ROCKY FLATS ENVIRONMENTAL TECHNOLOGY SITE

771 Closure Project Decommissioning Operations Plan Modification 4 and Proposed Action Memorandum for Under Building Contamination Remediation

September 6, 2001

Figure 2. 771 Closure Project Organization

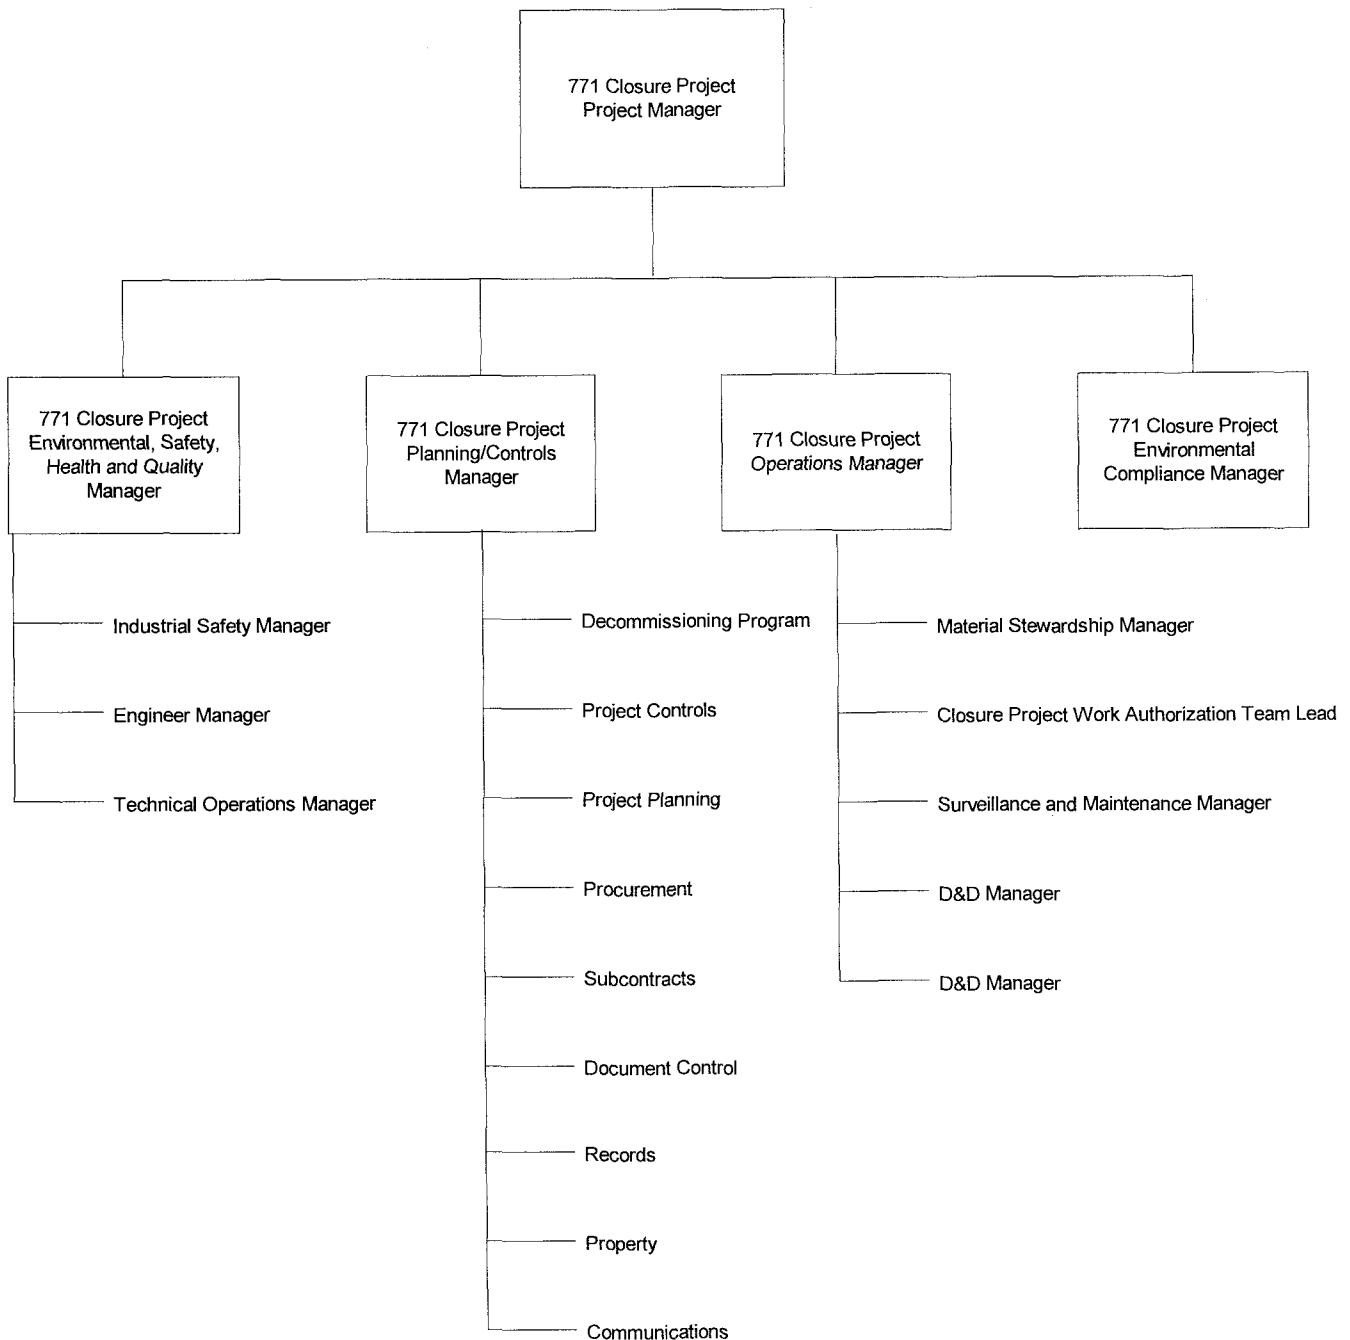
3	Page 10, Figure 2. 771 Closure Project Organization. Why does the project require two D&D Project Managers?	This section provides a brief description of the 771 Closure Project organization structure, functions, and interfaces as they pertain to facility management and decommissioning. The organizational structure is not an enforceable part of the DOP. The information requested is too detailed for the DOP modification.
4	Page 17, 3.1.2 Physical Interfaces. Define the interface between Building 771 personnel and Building 776 personnel when the tunnel is being remediated.	The tunnel will be dispositioned by the 771 Closure Project. Prior to initiating decommissioning activities, a barrier will be placed at the 776 opening to control the work area and prevent cross contamination.
5	Page 20, 4.3 Dismantlement Sets and Decommissioning Areas. Broomfield is concerned with the concept of having only Building Trades working in Areas with removable contamination less than 2,000 dpm without the support of Steelworkers, which have the process knowledge of the facility and known hazards associated with dismantlement of equipment. Clarify the need to distinguish between a dismantlement work set and a decommissioning area. All steps must be taken to protect the workers from potential situations that could lead to a plutonium uptake.	The distinction between sets and areas is made for work scope clarification and is based on the Project Labor Agreement. Work activities will be planned and executed in accordance with the RSOP for Facility Component Removal, Size Reduction, and Decontamination Activities, which is incorporated into the DOP through reference.
